WATERBURY FILING NO. 1 EL PASO COUNTY, CO CONSTRUCTION SET FEBRUARY 2023

EPC STORMWATER REVIEW COMMENTS IN ORANGE BOXES WITH BLACK TEXT

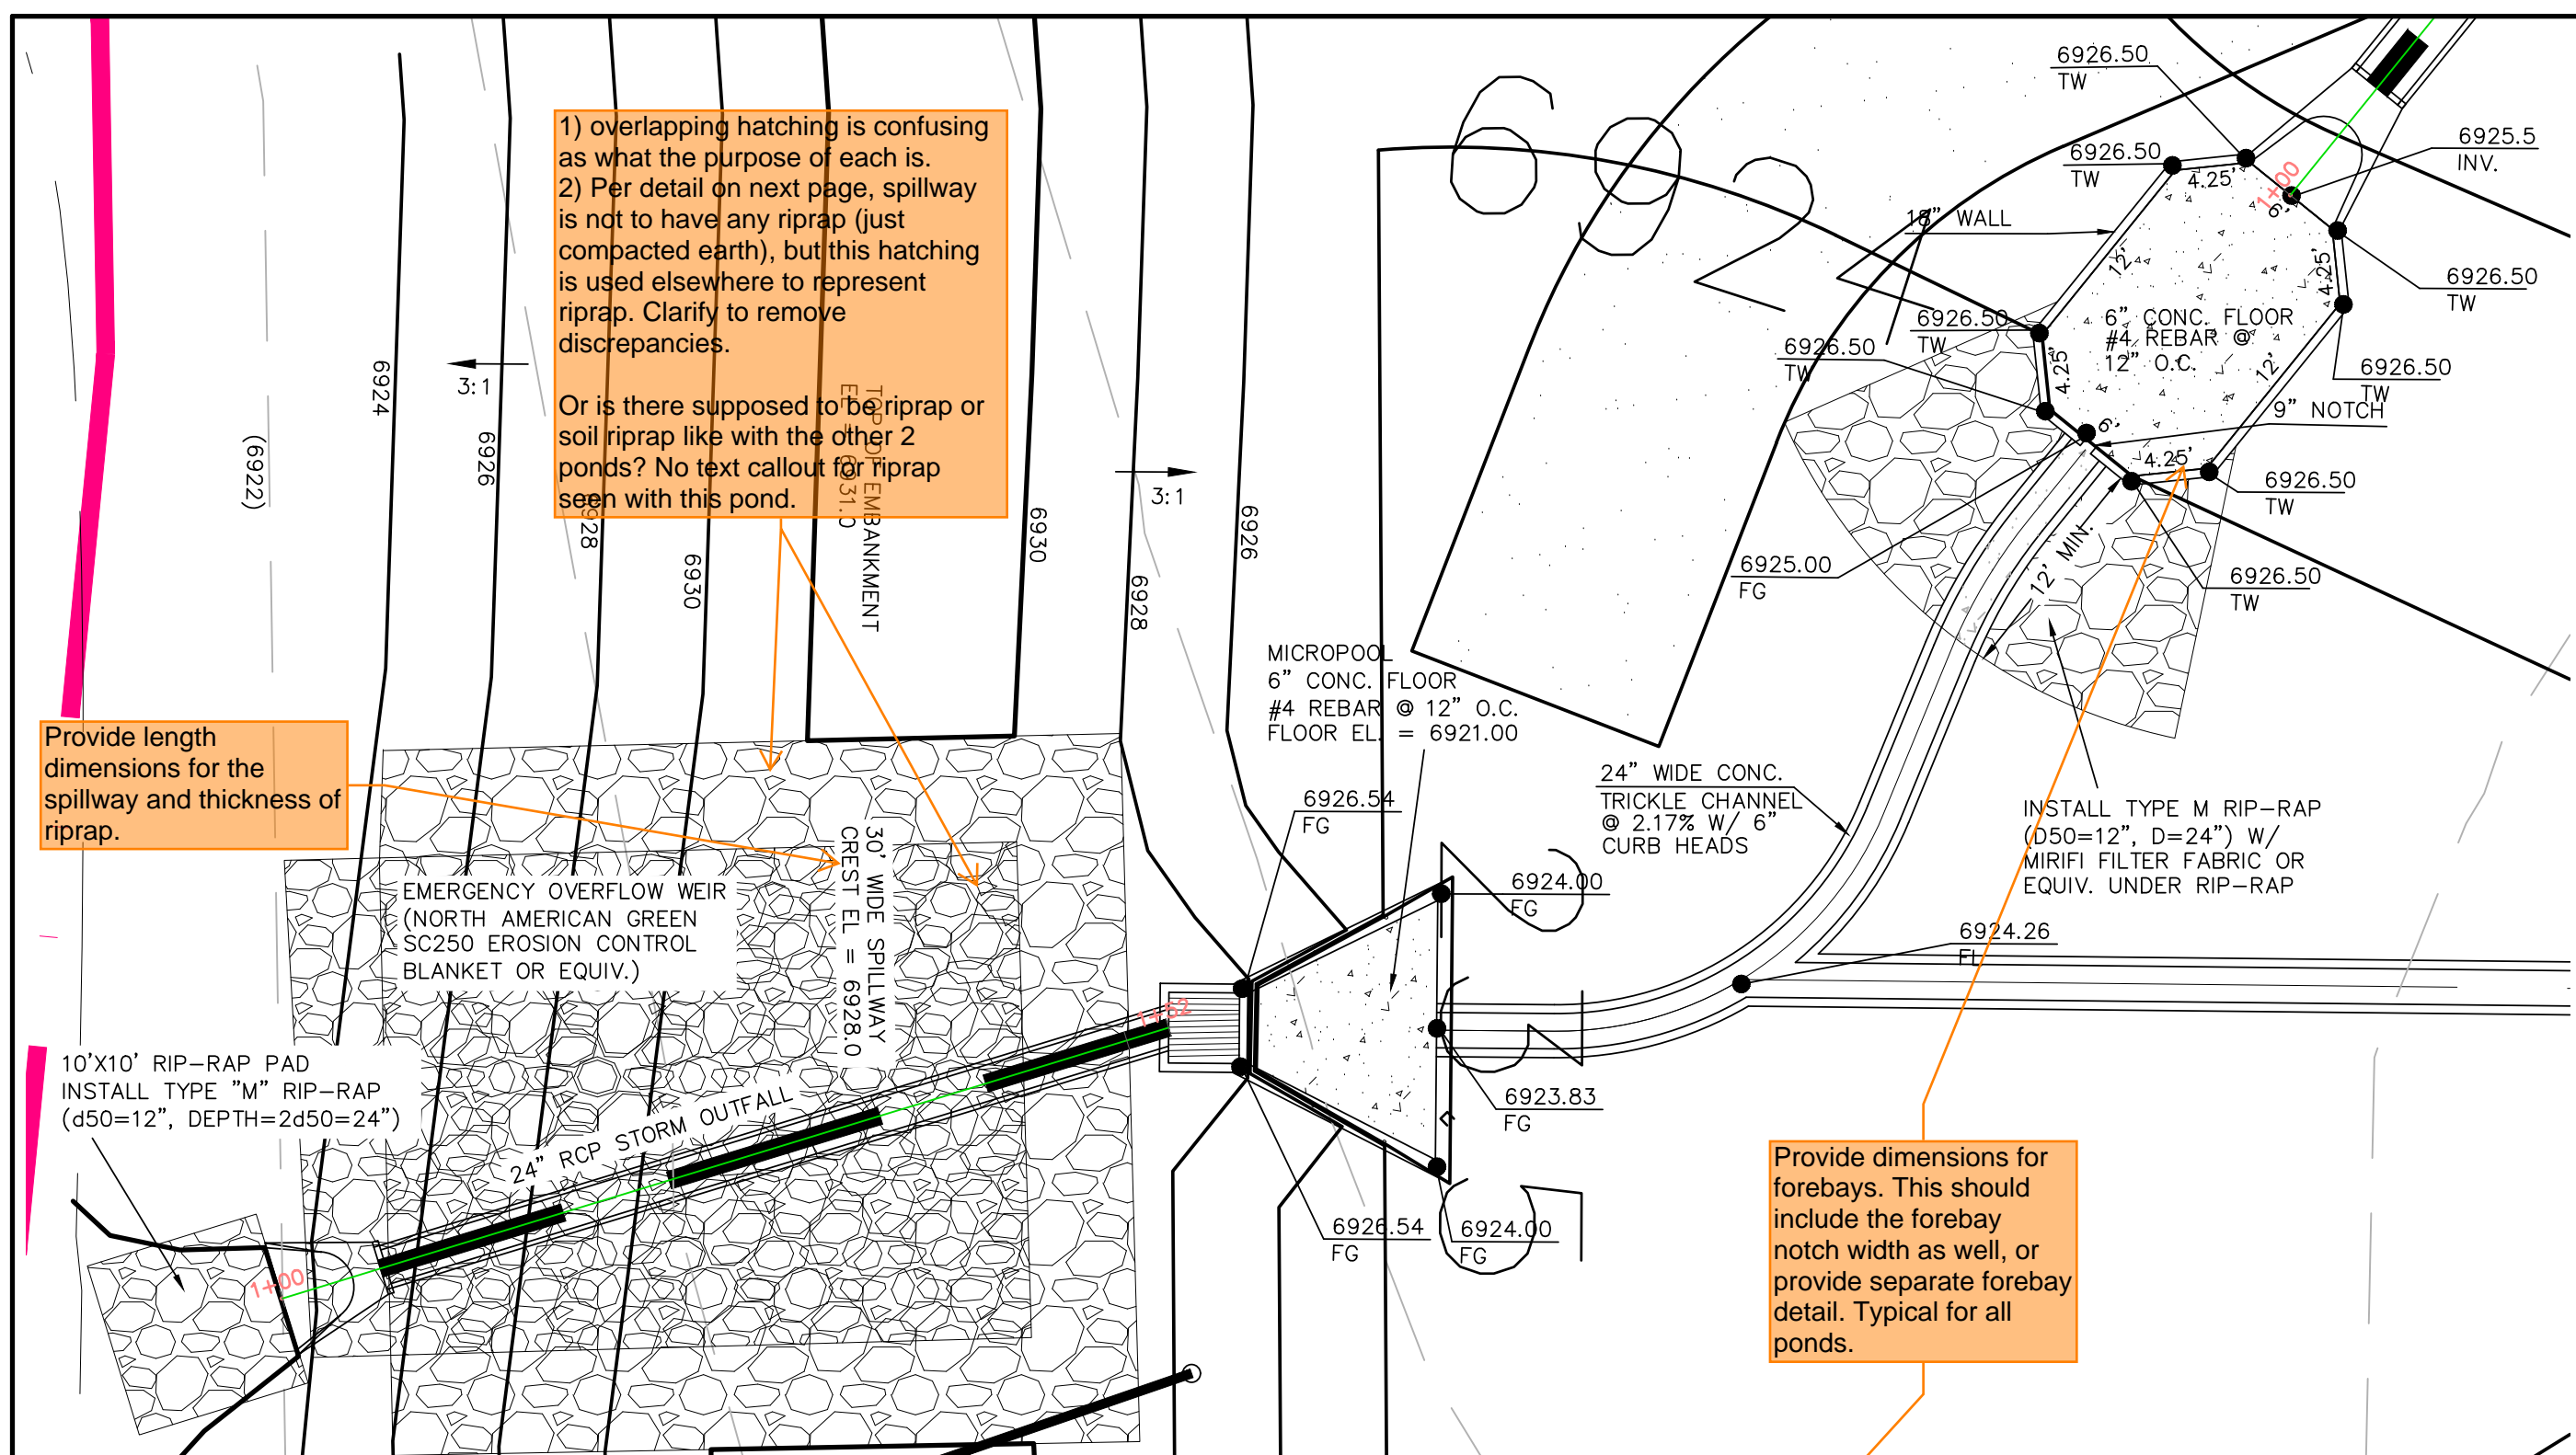
1) overlapping hatching is confusing as what the purpose of each is.  
 2) For detail on next page, spillway is not to have any riprap (just compacted earth), but this hatching is used elsewhere to represent riprap. Clarify to remove discrepancies.

Provide length dimensions for the spillway and thickness of riprap.

Provide dimensions for forebays. This should include the forebay notch width as well, or provide separate forebay detail. Typical for all ponds.

Provide the width as well.

Typical comment for all 3 ponds:  
 Pond bottom should have a minimum slope of 3% to the trickle channel and micropool (USDCM Vol 3, detail T-5). Please adjust to minimize future maintenance needs.

Revise to "Pond 1" for consistency with title block, details, and DR.

What are these station lines for? Update or remove?

Show easement around pond and access for all ponds

move or delete misplaced callouts

Typical comment for all 3 ponds:  
 Include callout for pet waste station(s) around the pond, with signage stating that pet waste must be picked up.
